RSL LifeCare Montgomery Centre ANZAC Village DA SUBMISSION

REVISION NOTES:
Revision Cloud 1 = Deletion of previously proposed mechanical exhausts stacks (x2), condenser platform, and access ladder.
Revision Cloud 2 = Previously proposed platform for mechanical condensers shifted from west to east. Louvred screen to conceal condensers added to south and west facing side of platform.
Revision Cloud 3 = Stairs increased width and the ramp moved next to the existing building.
Revision Cloud 4 = Parking near the Memorial Stage and planter walls design amendments.
Revision Cloud 5 = View of southern side of hall shows of deletion of previously proposed mechanical exhausts stacks (x2), platform, and access ladder. Louvred screen to conceal condensers platform can be seen.
Revision Cloud 6 = Finishes materials added
Revision Cloud 7 = Previously Anzac memorial was demolished. New proposal to retain the existing Anzac memorial and extend as represented in the proposed plans.

project Anzac Village-Montgomery Centre		date 7/5/2025	revision issue 06
project number 23010	client RSLLC	drawing scale @ A1	drawing number A000
drawing COVER PAGE

SOUTHERN ELEVATION (RAMP)
1:100

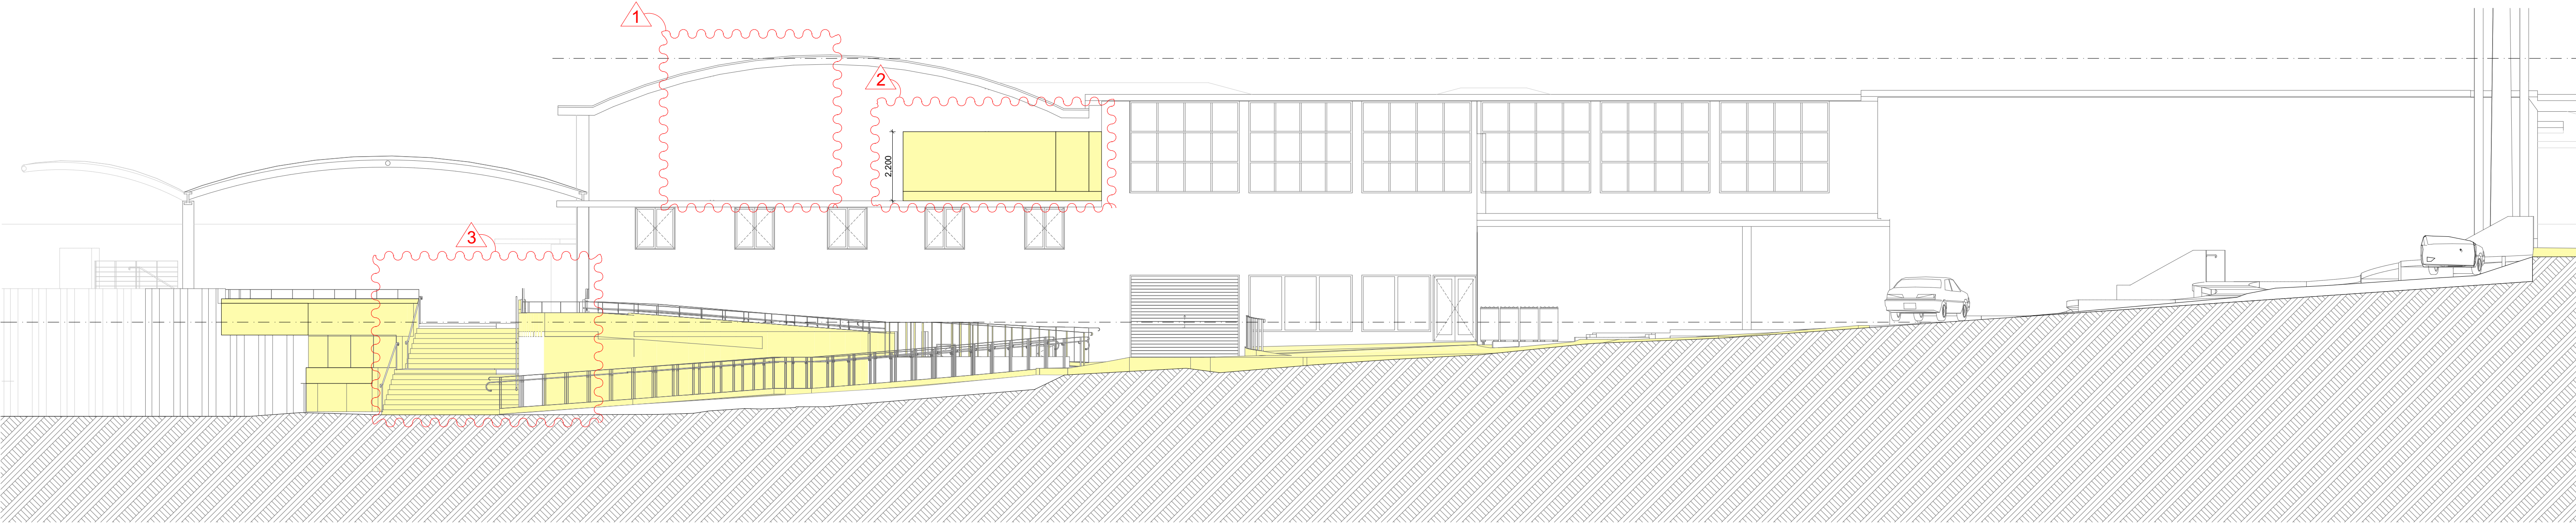
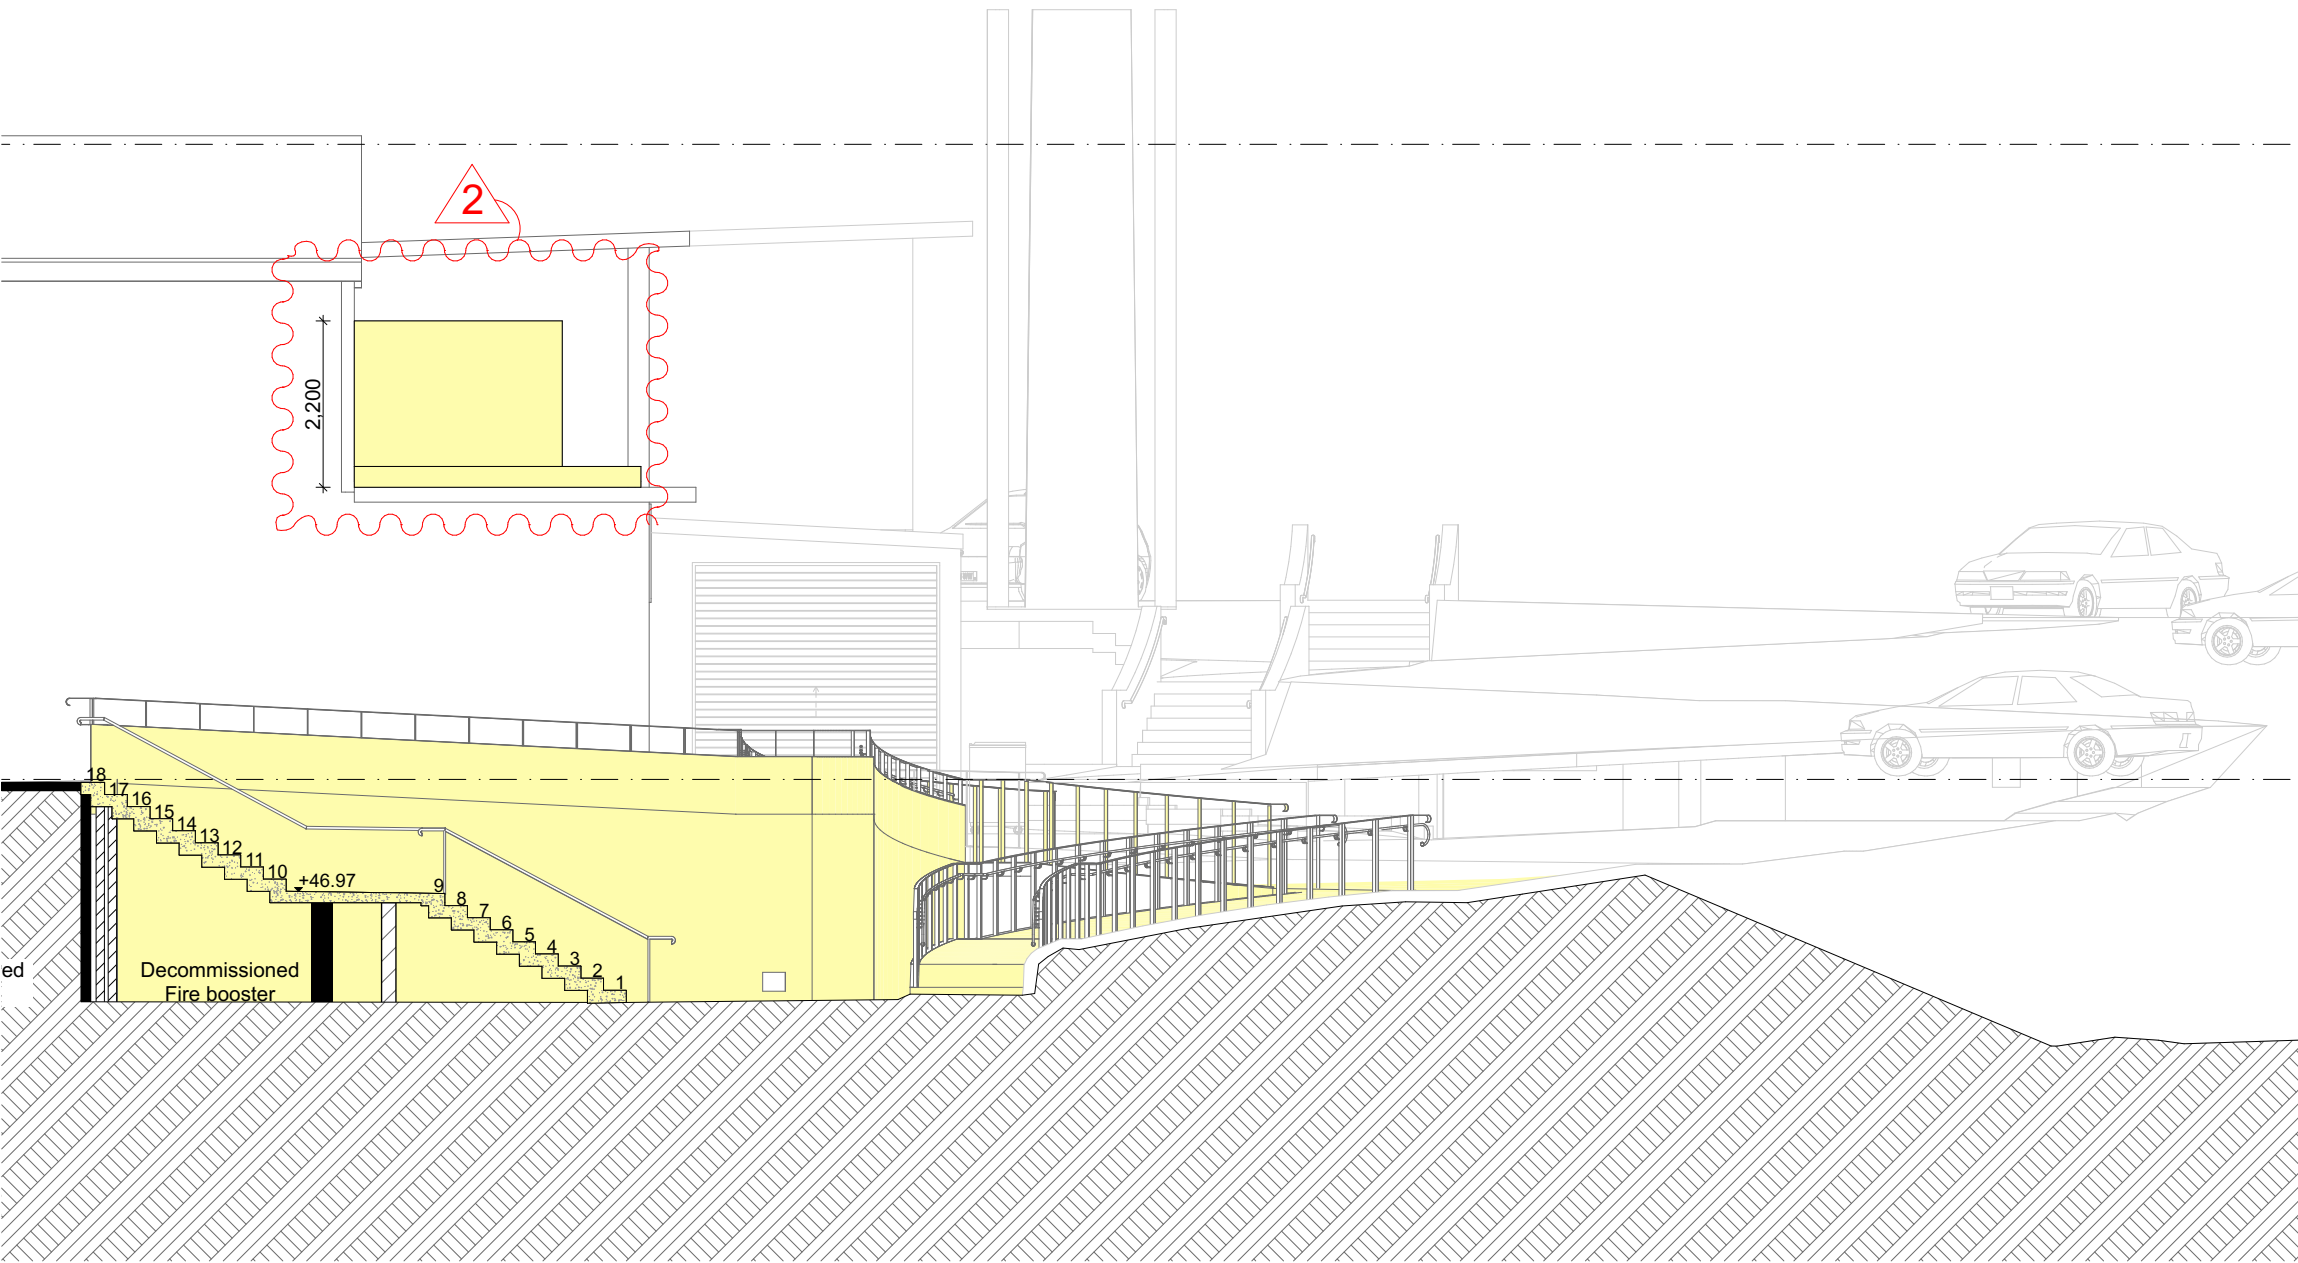
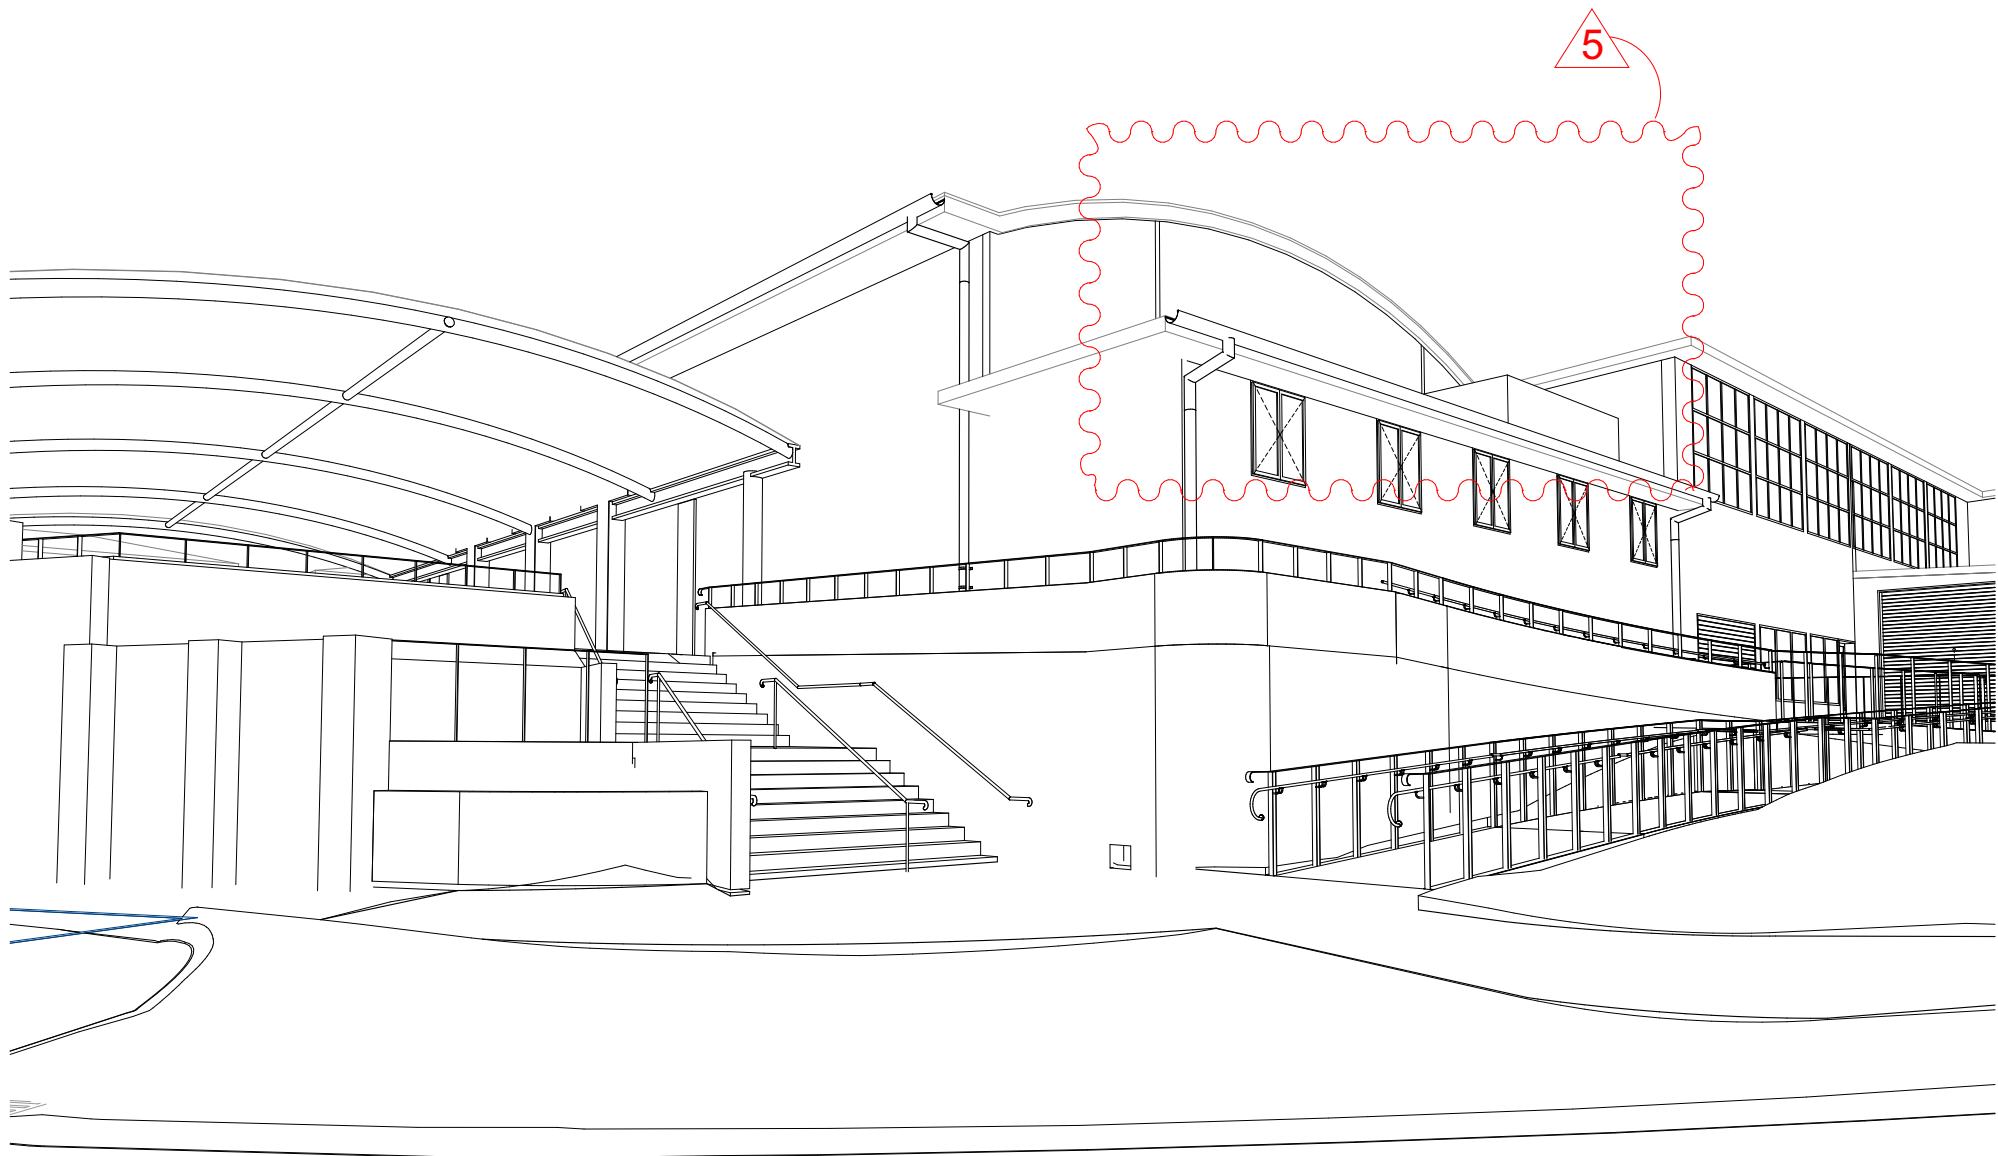
REVISION NOTES:
Revision Cloud 1 = Deletion of previously proposed mechanical exhausts stacks (x2), condenser platform, and access ladder.
Revision Cloud 2 = Previously proposed platform for mechanical condensers shifted from west to east. Louvred screen to conceal condensers added to south and west facing side of platform.
Revision Cloud 3 = Stairs increased width and the ramp moved next to the existing building.
Revision Cloud 4 = Parking near the Memorial Stage and planter walls design amendments.
Revision Cloud 5 = View of southern side of hall shows of deletion of previously proposed mechanical exhausts stacks (x2), platform, and access ladder. Louvred screen to conceal condensers platform can be seen.
Revision Cloud 6 = Finishes materials added

project	Anzac Village-Montgomery Centre		date	7/5/2025	revision issue	06
project number	23010	client	RSLLC			
drawing	STAGE ELEVATIONS		drawing scale	1:50 @ A1	drawing number	A201

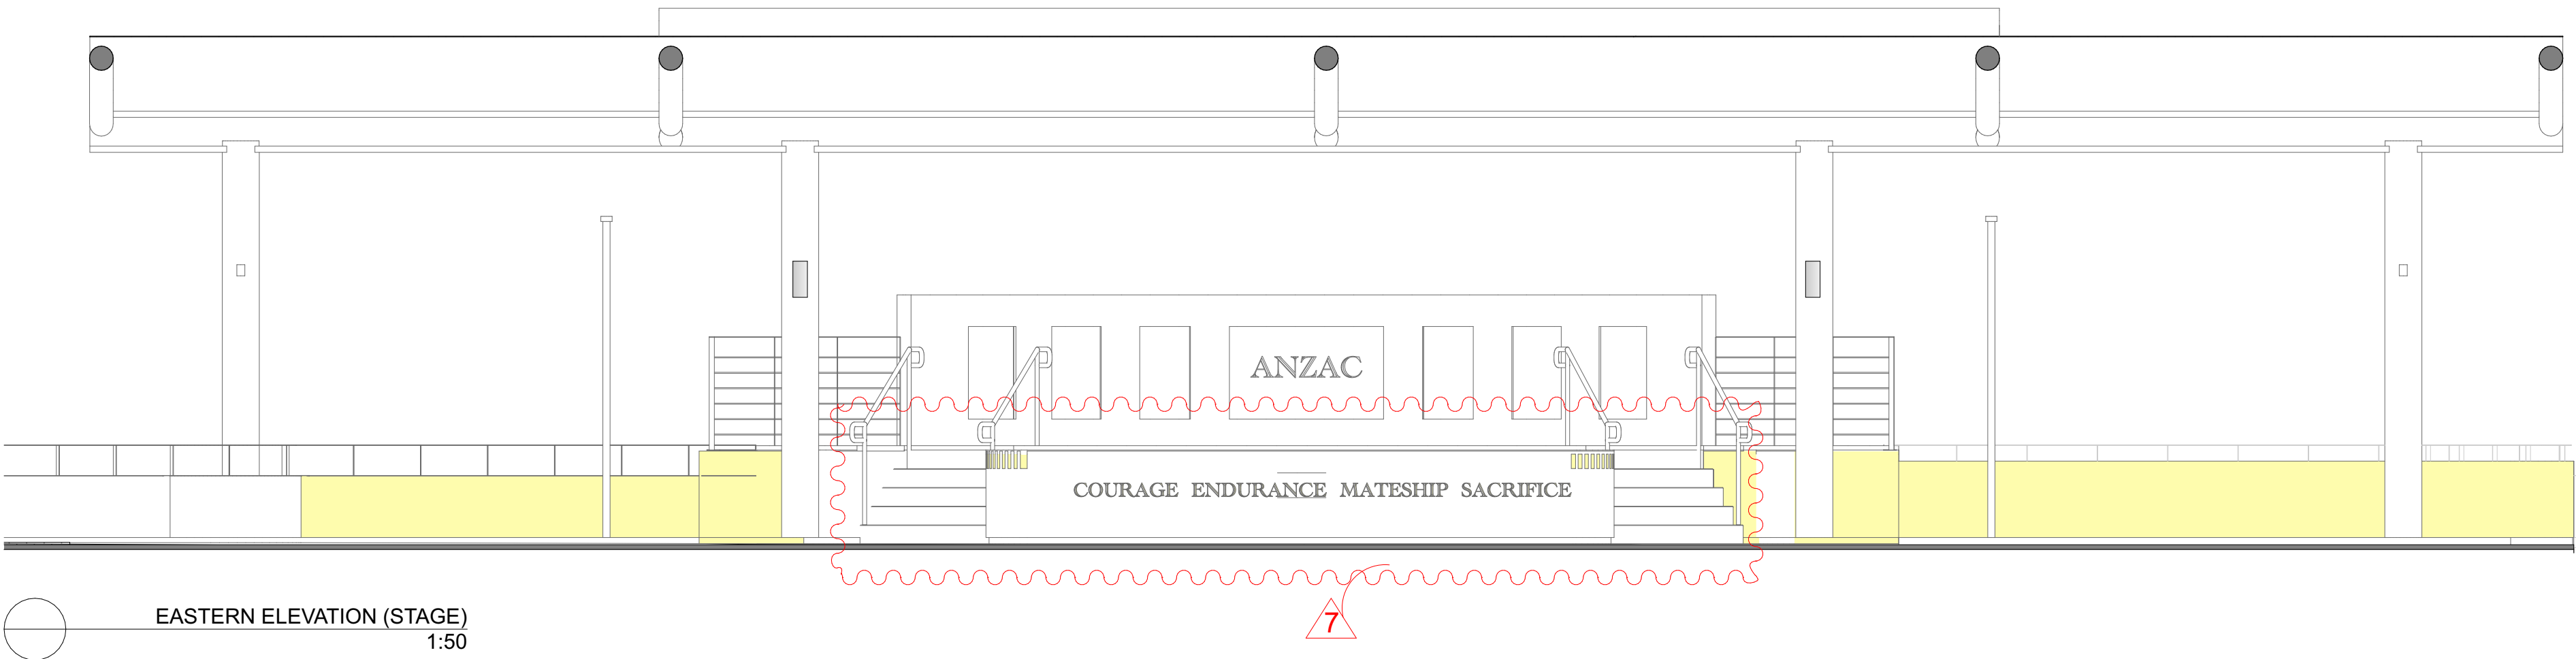
REVISION NOTES:
Revision Cloud 1 = Deletion of previously proposed mechanical exhausts stacks (x2), condenser platform, and access ladder.
Revision Cloud 2 = Previously proposed platform for mechanical condensers shifted from west to east. Louvred screen to conceal condensers added to south and west facing side of platform.
Revision Cloud 3 = Stairs increased width and the ramp moved next to the existing building.
Revision Cloud 4 = Parking near the Memorial Stage and planter walls design amendments.
Revision Cloud 5 = View of southern side of hall shows of deletion of previously proposed mechanical exhausts stacks (x2), platform, and access ladder. Louvred screen to conceal condensers platform can be seen.
Revision Cloud 6 = Finishes materials added
Revision Cloud 7 = Previously Anzac memorial was demolished. New proposal to retain the existing Anzac memorial and extend as represented in the proposed plans.
